Bulletin No. 08-006

Subject – Setting a SIU or SCU to match HF USBL Scout Transceiver auxiliary port serial interface protocol (RS232 or RS485).

Main board inside SCU and SIU showing 2 rotary switches.

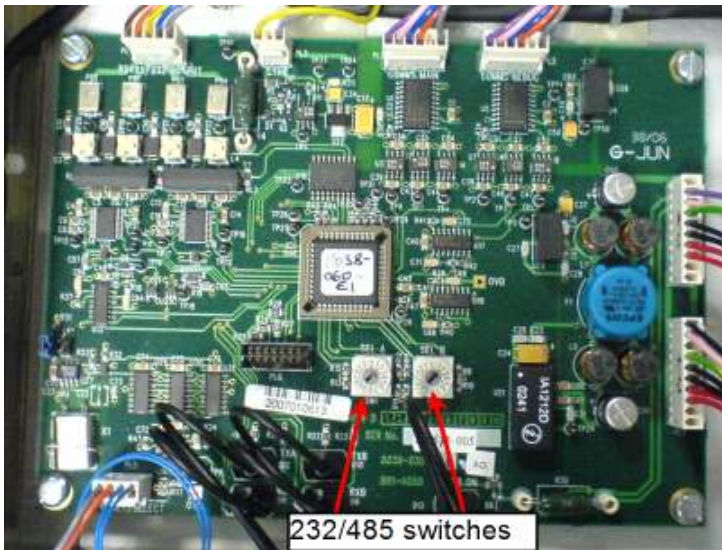
Customer driven requests to use long cabling with the Scout transceiver has resulted in a requirement for RS485 comms protocol instead of RS232. The result of this change is that the surface interface units require reconfiguring **when swapping between old and new transceivers**. 8024 Transceivers built from Jan 2008 onwards are marked with a label denoting the comms protocol. Transceivers older than this date will be RS232 comms.

If using a transceiver sold before 2008 then it is likely to be installed with an internal motion sensor that is factory configured for RS232 protocol and therefore the switch settings, as shown above, should be both set to 3.

If using a more modern transceiver than Jan 2008 there will be a label denoting that the internal motion sensor comms are configured for RS485 and therefore the switches should be both set in position 2.
